BRICKLIGHT COURTYARDS
LOTS 6-10 AND 17-21
BLOCK 1
UNIVERSITY HEIGHTS

CITY OF ALBUQUERQUE,
IMPROVEMENTS FOR
PAVING AND WATER

AS-BUILT CERTIFICATION

I, Billy O. McCarty, NMPE 13672, of the firm BEAM Designs, hereby certify that this project has been constructed in substantial compliance with and in accordance with the design intent of the approved plans dated 07/11/07. The record information edited onto the original design document has been obtained by Michael Trujillo, NMPS 11993, of the firm. Precision Surveys, Inc. I further certify that I have personally visited the project site during construction between the dates of 02/21/07 and 01/14/08 and have determined by visual inspection that the survey data provided is representative of actual site conditions and is true and correct to the best of my knowledge and belief. This certification is submitted in support of a request for Final Acceptance.

② BRICK PLANTER/BENCH DETAIL

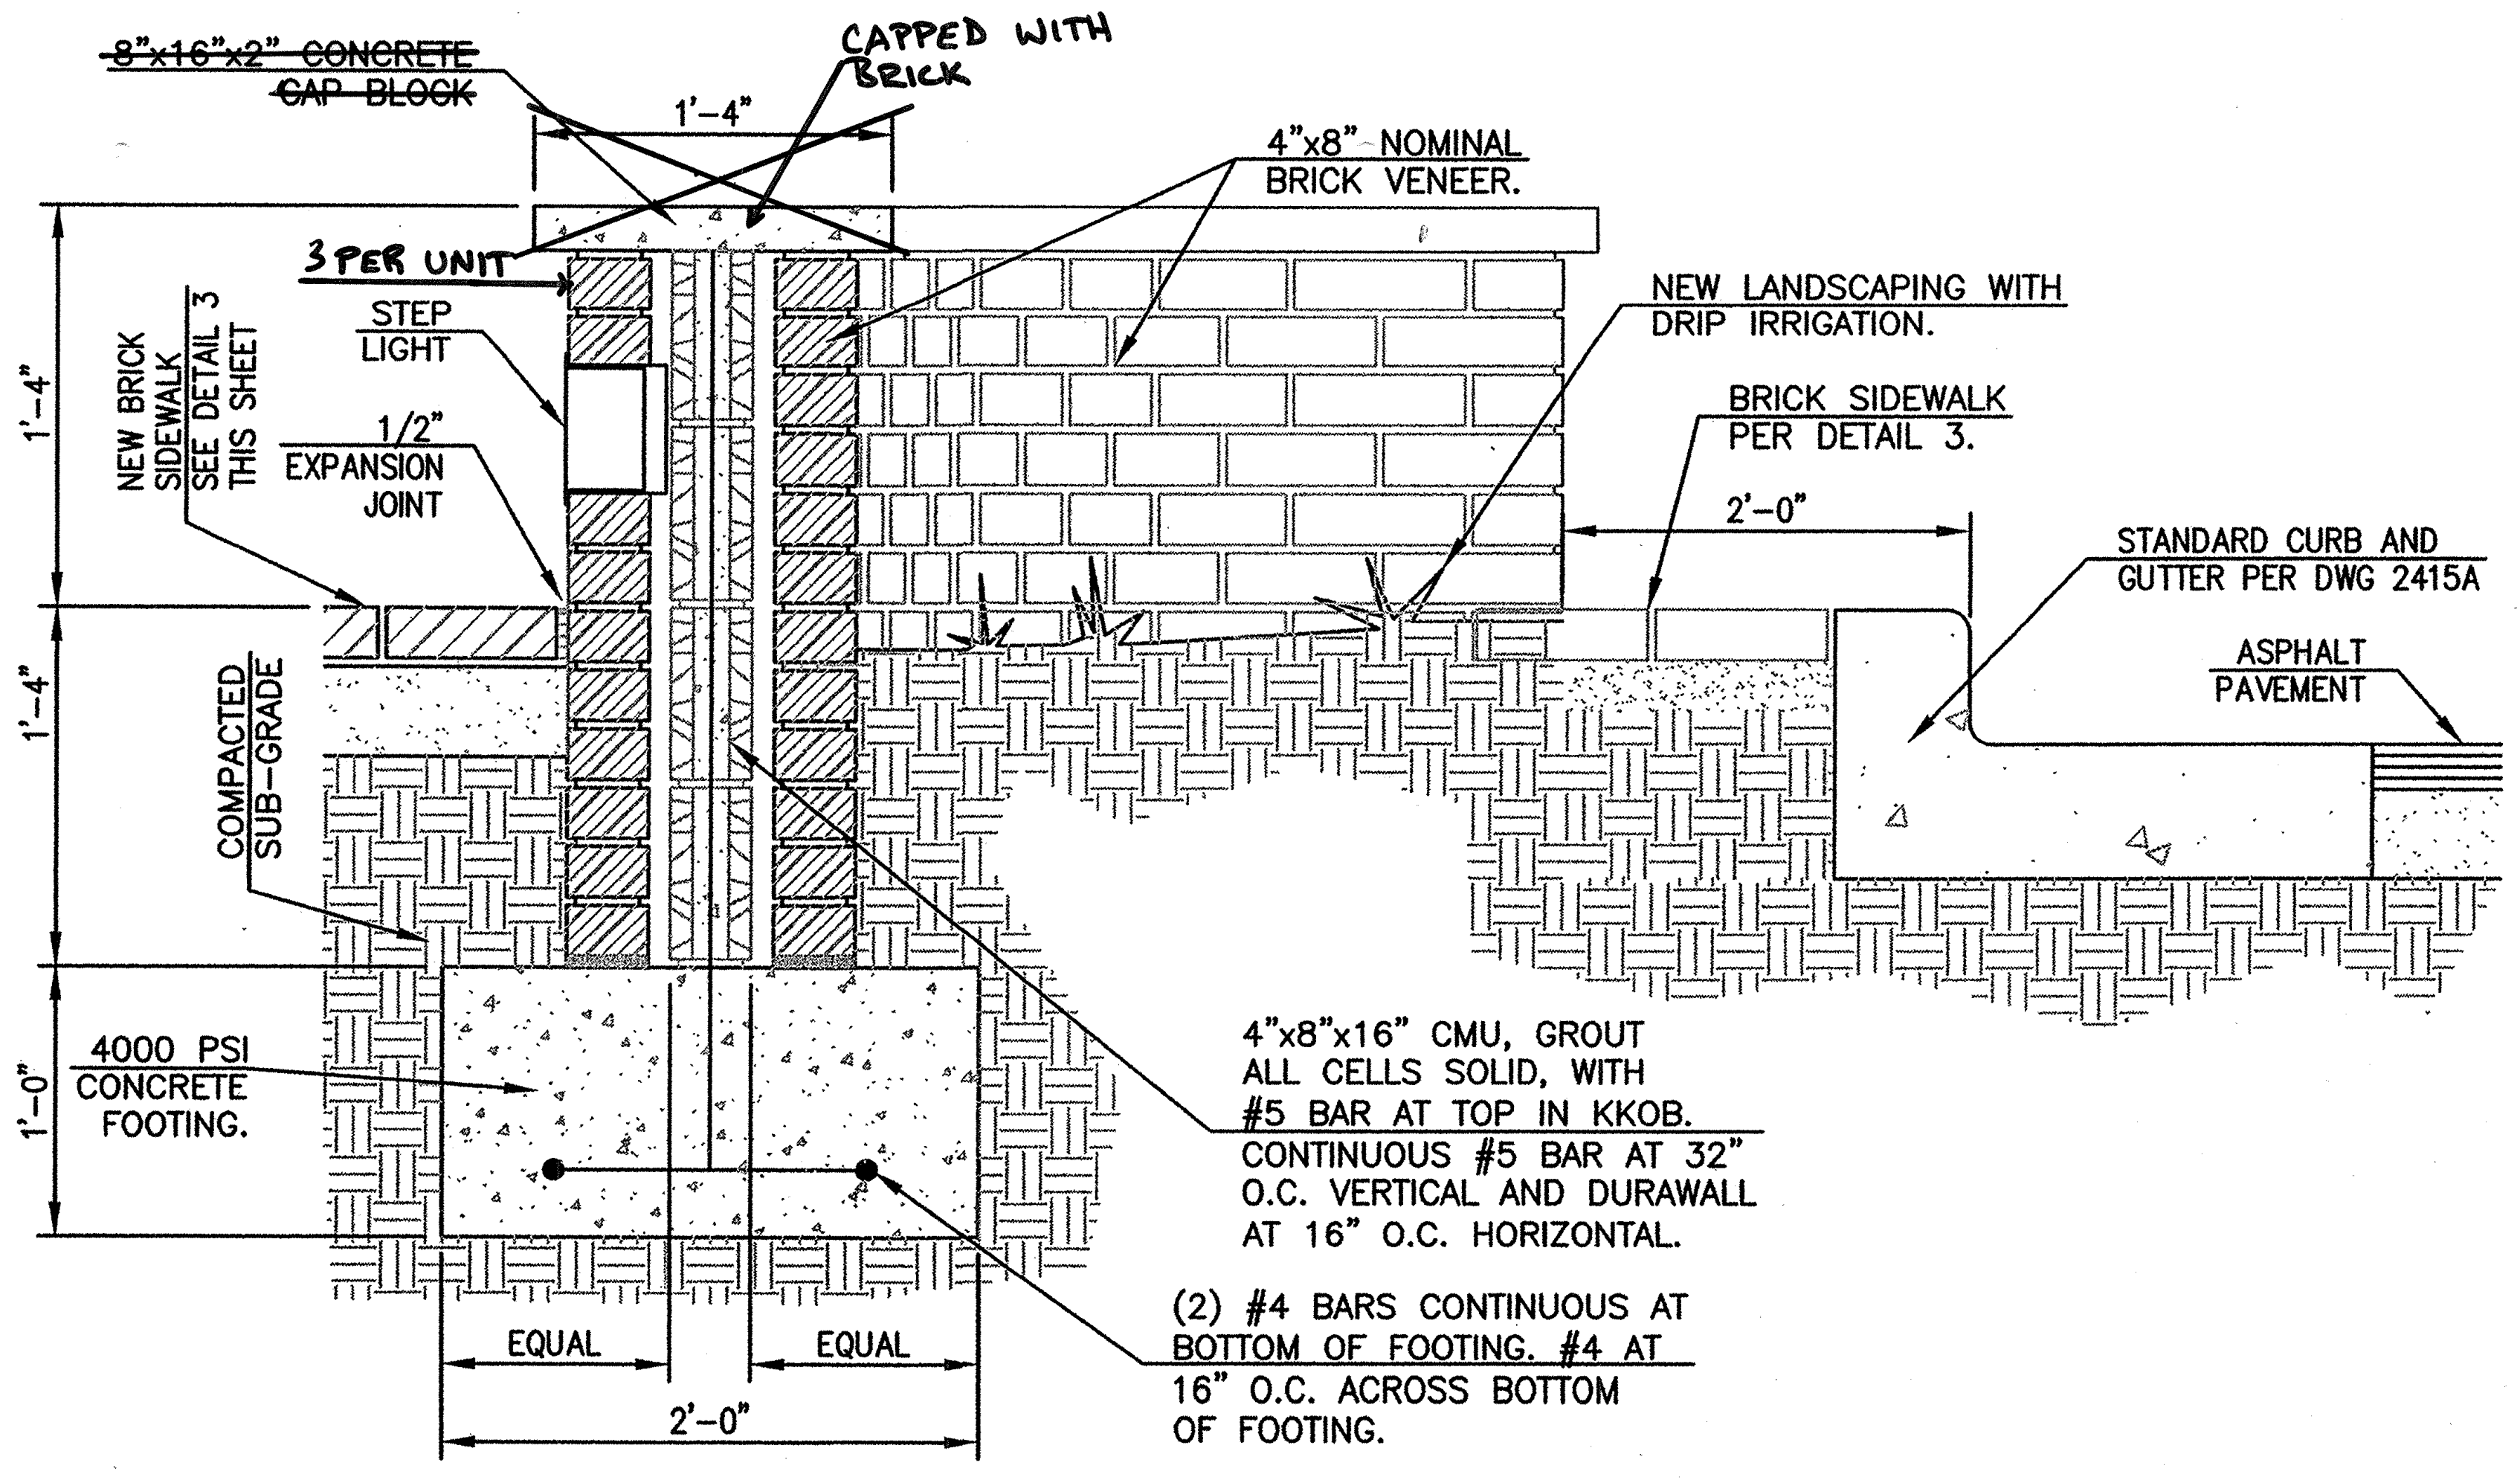
~~8"x16"x2" CONCRETE CAP BLOCK~~
CAPPED WITH BRICK
1'-4"
4"x8" NOMINAL BRICK VENEER.
3 PER UNIT
STEP LIGHT
1/2" EXPANSION JOINT
NEW BRICK SIDEWALK SEE DETAIL 3 THIS SHEET
NEW LANDSCAPING WITH DRIP IRRIGATION.
BRICK SIDEWALK PER DETAIL 3.
2'-0"
STANDARD CURB AND GUTTER PER DWG 2415A
ASPHALT PAVEMENT
1'-4"
1'-4"
COMPACTED SUB-GRADE
1'-0"
4000 PSI CONCRETE FOOTING.
4"x8"x16" CMU, GROUT ALL CELLS SOLID, WITH #5 BAR AT TOP IN KKOB. CONTINUOUS #5 BAR AT 32" O.C. VERTICAL AND DURAWALL AT 16" O.C. HORIZONTAL.
(2) #4 BARS CONTINUOUS AT BOTTOM OF FOOTING. #4 AT 16" O.C. ACROSS BOTTOM OF FOOTING.
EQUAL
EQUAL
2'-0"

STA ~~13+57.51~~ MATCH GUTTER CONSTRUCTION JOINT. SAW CUT 12' INTO EXISTING ASPHALT

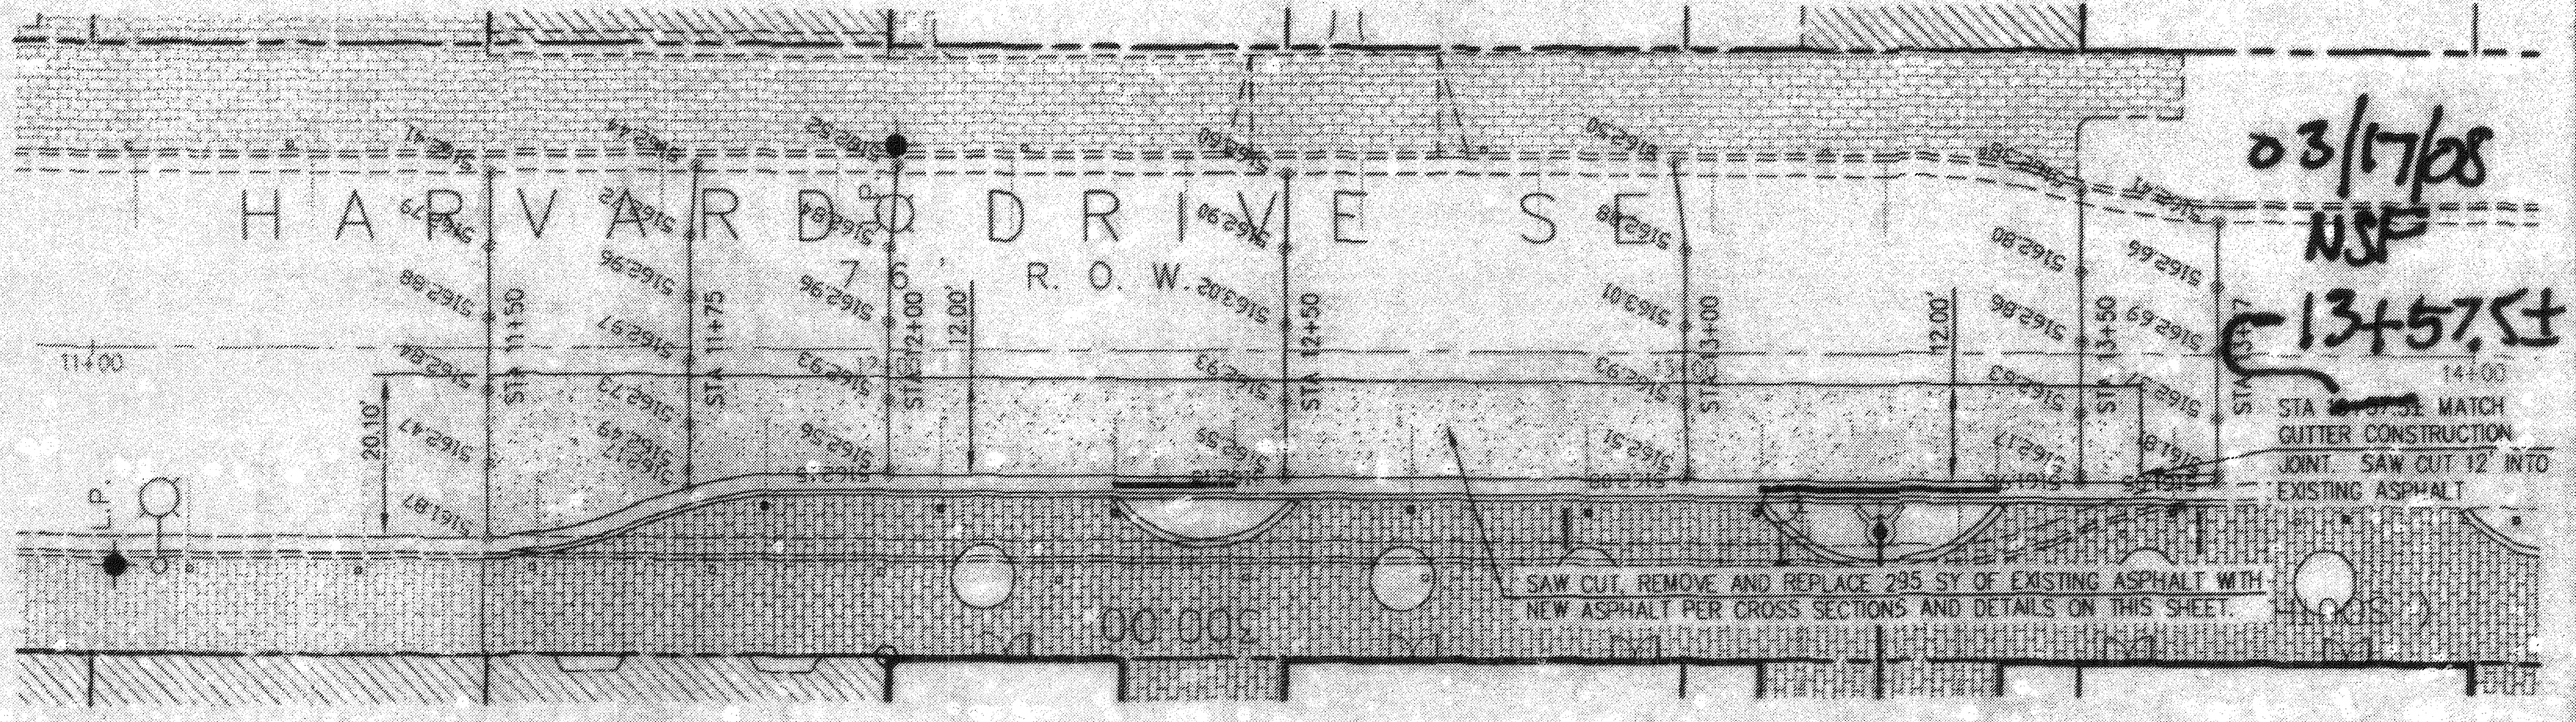
03/17/08
NSF
13+57.5±
